5 December 2016

# Re: CP16-001 Arrawarra Seawall - Applicant Arrawarra Beach Pty Ltd

Reference is made to the above Development Application and the assessment prepared by City Plan Services (CPS), 1 December 2016, and the memo to Marc Daley, OEH, prepared by Gary Blumberg of Royal Haskoning (RH) DHV of 30 November 2016 on behalf of the Panel.

# Attachment A:

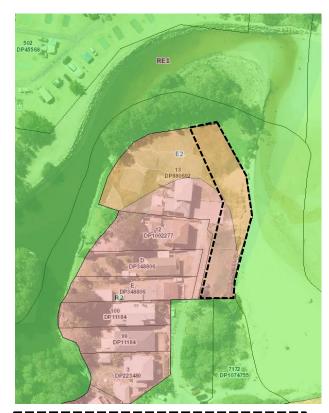
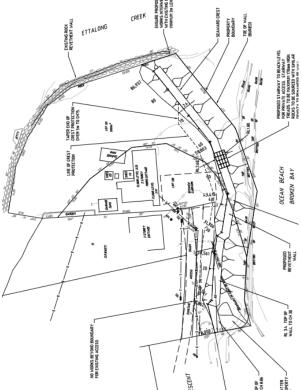
A map showing the site boundary in relation to the mapped area of littoral rainforest is provided at Attachment A. Note that the revetment is located within the 100 m wide buffer to the littoral rainforest and is separated from the mapped littoral rainforest by Yarrawarra Creek and a nature reserve (Coffs Coast Regional Park). The Minister's Concurrence was granted pursuant to SEPP 26 Littoral Rainforests to DA 0667/16DA, copy attached. The concurrence was granted subject to proposed revegetation including littoral rainforest species. The preliminary Vegetation Management Plan includes littoral rainforest species.

# Attachment C.

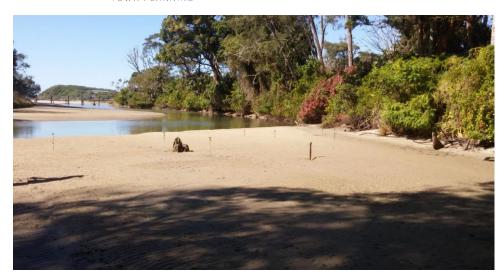
- Access impact no further issues.
- Visual impact CPS concerned with the visual impact of vegetation clearance to accommodate the revetment. See Attachment C for existing site photos and proposed landscape treatment. Visual amenity within the E2 zone will improve significantly as a result of the development.

No significant vegetation in the E2 zone.

As detailed in the preliminary Vegetation Management Plan, tree removal in the E2 zone will be offset by replacement trees, shrubs and groundcovers using native species within the available space between the proposed revetment and the residential zone boundary. This will result in a significant visual improvement both from within the site and to the site from surrounding vantage
